# Service Bulletin

Bulletin No.: 23-NA-142

**Subject: No Forward Gear When Shifting from Park to Drive and/or Reverse to Drive**

Brand:	Model:	Model Year:		VIN:		Engine:	Transmission:
		from	to	from	to		
Chevrolet	Express	2017	2023				6L90 (MYD)
GMC	Savana

6404809

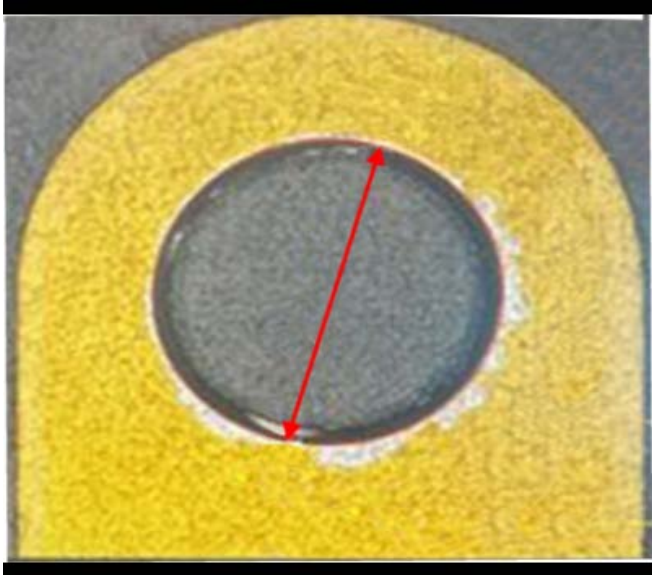
- The seat for the check ball is out of spec relative to coin depth. This potentially can cause burrs, dents, or dings, which could cause the plastic check ball to wear prematurely.

- The #1 check ball has a high duty cycle and when combined with the issue, there is a possibility for the check ball to wear and then become stuck or pass through the spacer plate.

Replace the spacer plate and check ball.

6404322

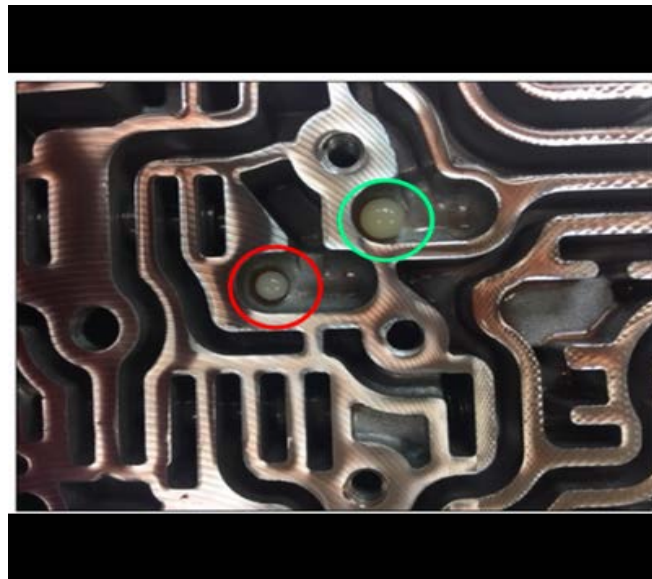
- As indicated in the graphic above, the check ball circled in RED has prematurely worn down. It should be the same diameter as the check ball circled in GREEN.
